BASIN DESIGN ADDENDUM

November 18, 2019

Section 10.0 Basin & Channel Design Guidelines of current adopted standards remain in place with the following exceptions:

TYPICAL BASIN SUBDRAINS VALLEY-WIDE MAINTAINED DRAINS

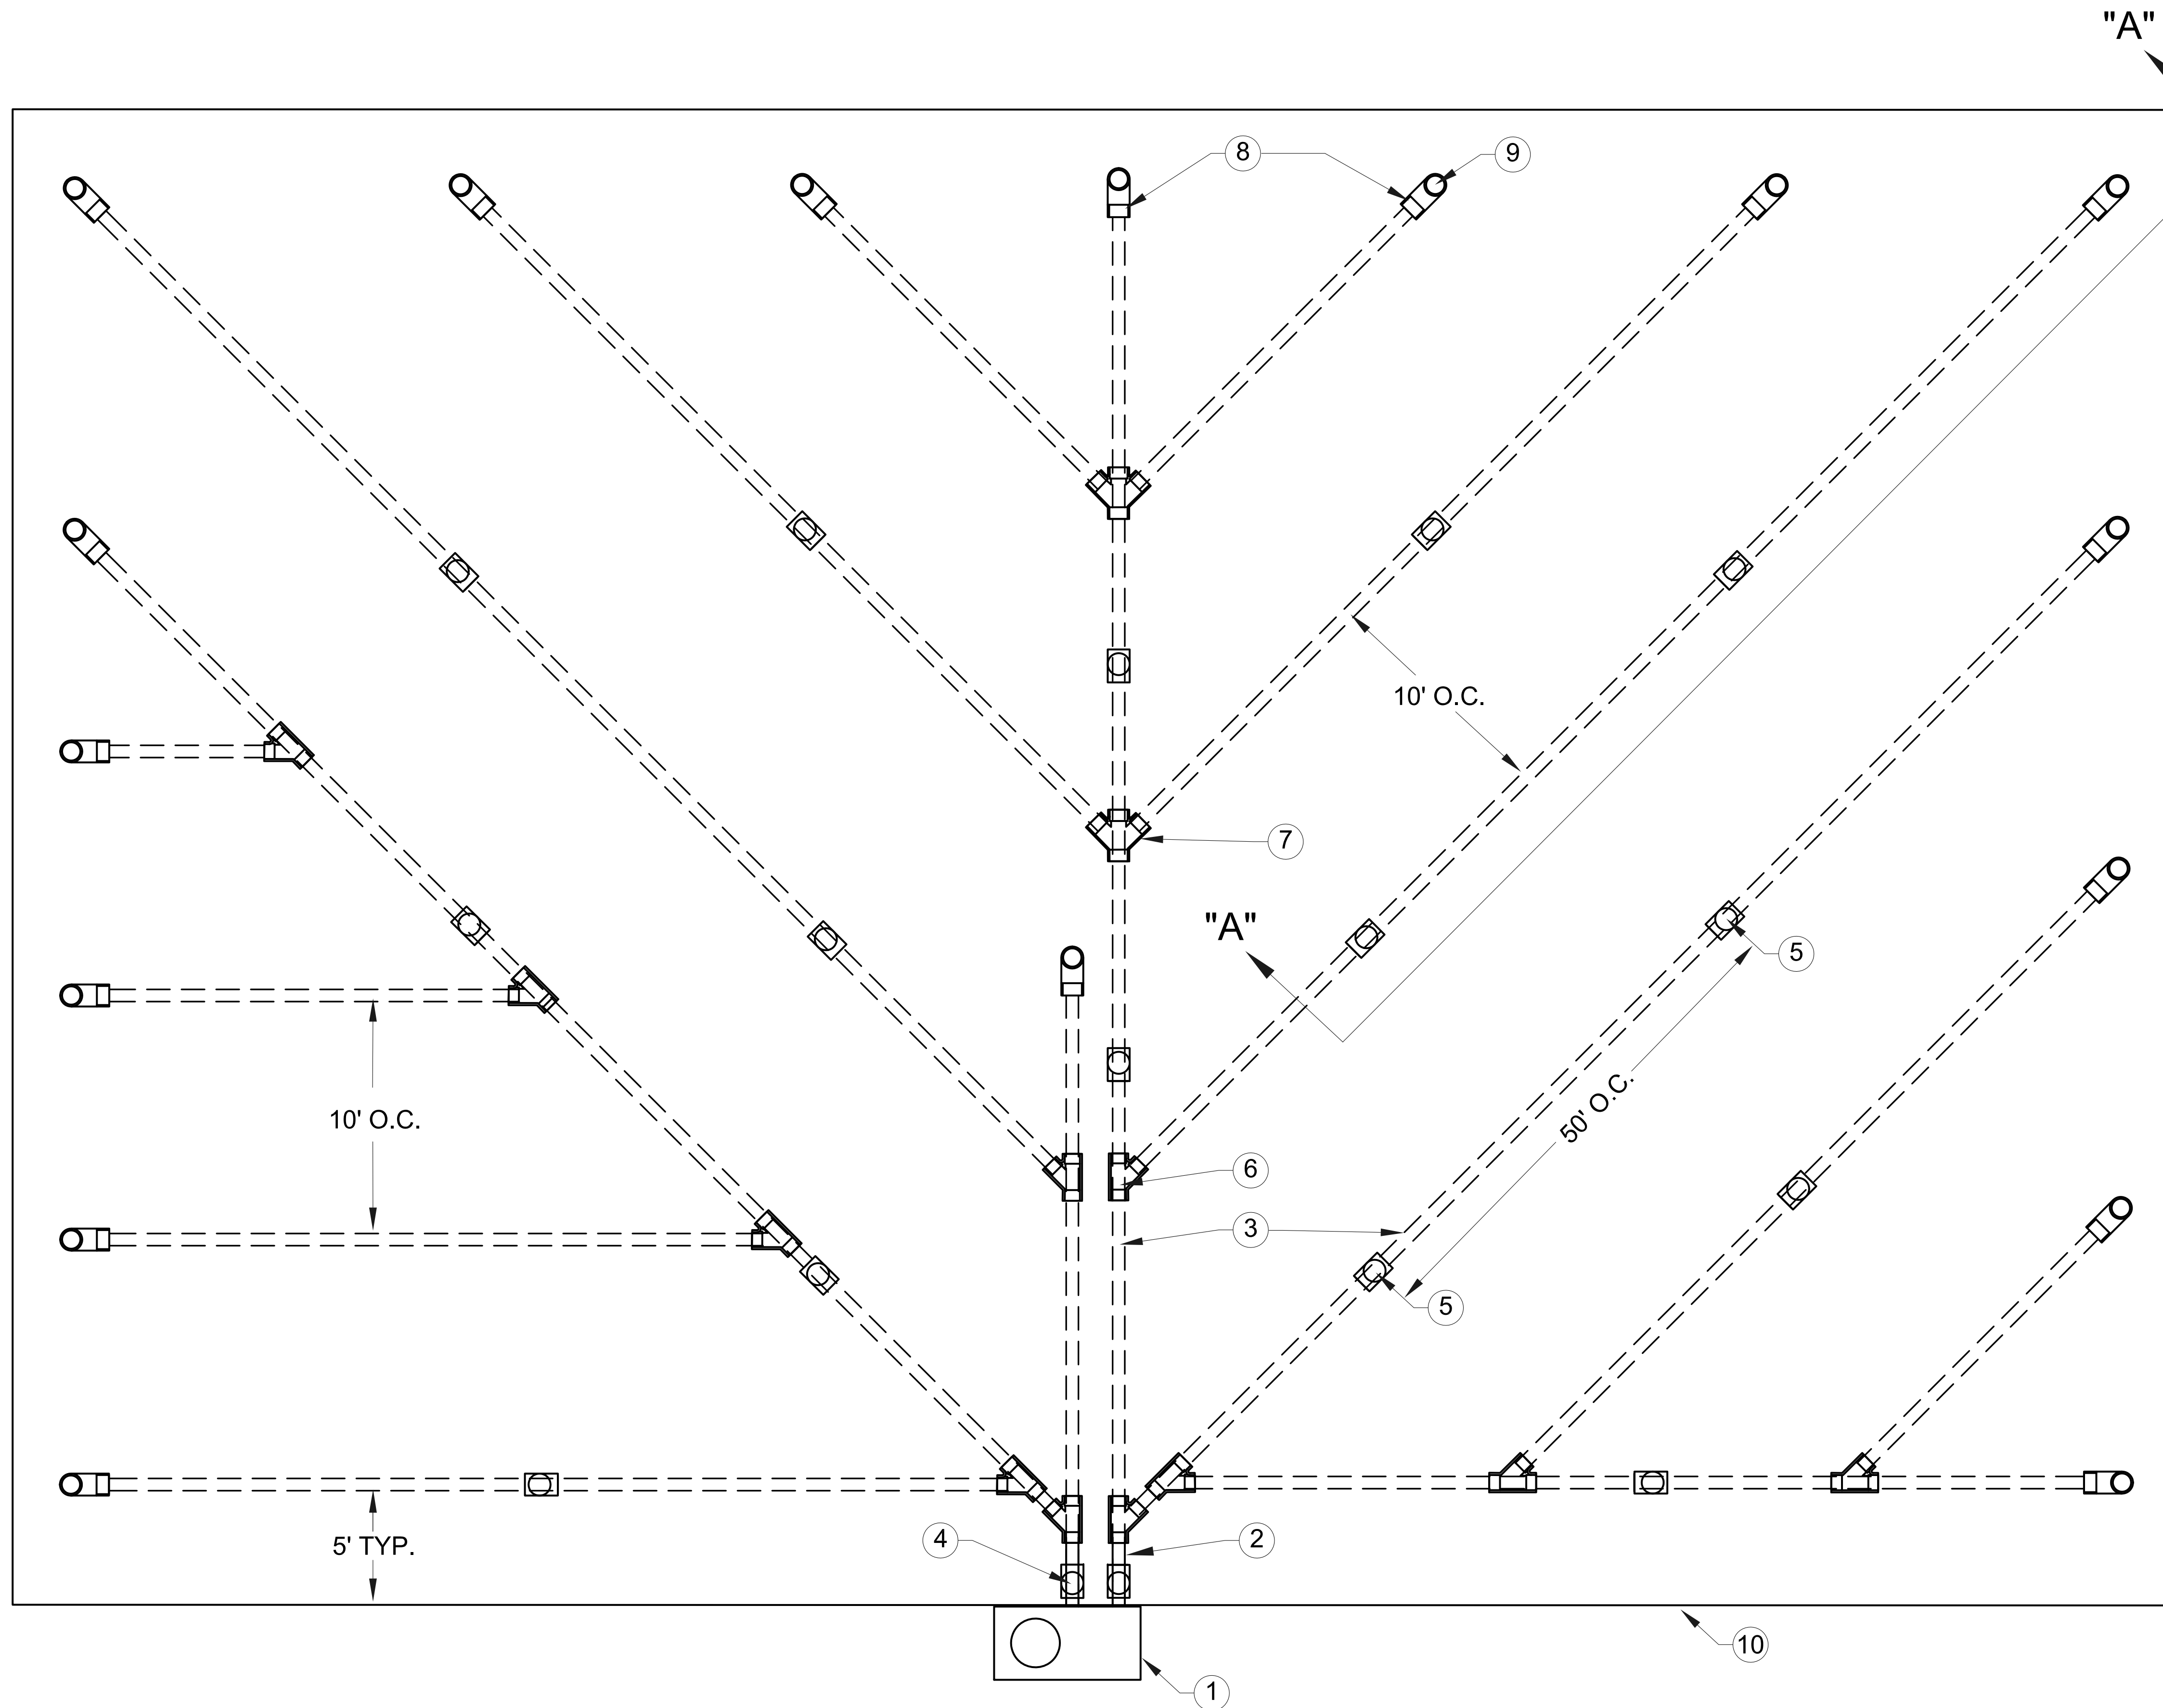
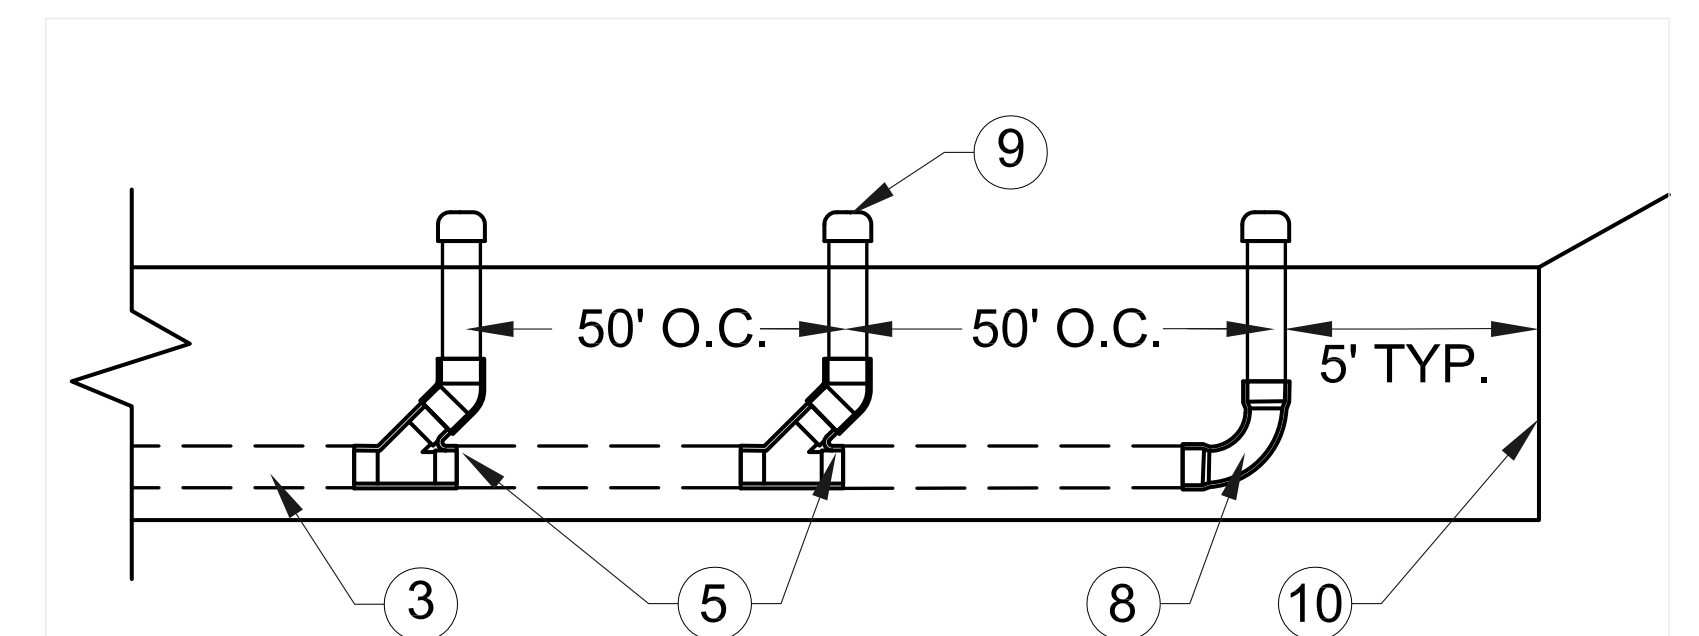
2. Section 10.2 Grading, C, indicates, low flow drainage must be installed per Valley-Wide low-flow drainage typical detail. Included within this addendum is a Typical Basin Sub-drain Exhibit.
In addition to this, each project must comply with the County's Low Impact Design Manual.

- a. All piping must be 6" diameter SCH 40 PVC piping.
 - b. All piping fittings must be SCH 40 PVC.
 - c. All piping must have a minimum slope of 0.50% and should match the basin bottom slope of 0.50%.

- d. Horizontal piping must be spaced no further than 10 feet apart within all water quality treatment areas.
 - e. All pipe fittings with change of directions cannot exceed 45 degrees.

- f. All clean-outs must be installed with 6" SCH 40 PVC combination wyes and 1/8 bends with risers exposed 6" above the media surface with removable caps to access piping for maintenance operations. Clean-outs must be provided at 50' spacing.

- g. All pipe ends must have clean-out risers with 6" SCH 40 PVC "Long Sweep" elbows.
 - h. Whenever possible, piping runs should flow directly towards outlet structures not exceeding 45 degree change of direction.

- i. Perforated pipe and rock must be protected with nonwoven geotextile filter fabric Mirafi® 140N or approved equal. The use of appropriately sized filtering aggregates may be used in place of filter fabric, as approved by Valley-Wide.

- j. Multiple pipe connections into outlet structures are required for basin areas over 3,000 square feet.
 - k. A 6" diameter SCH 40 PVC observation well shall be provided prior to each connection to the outlet structure.
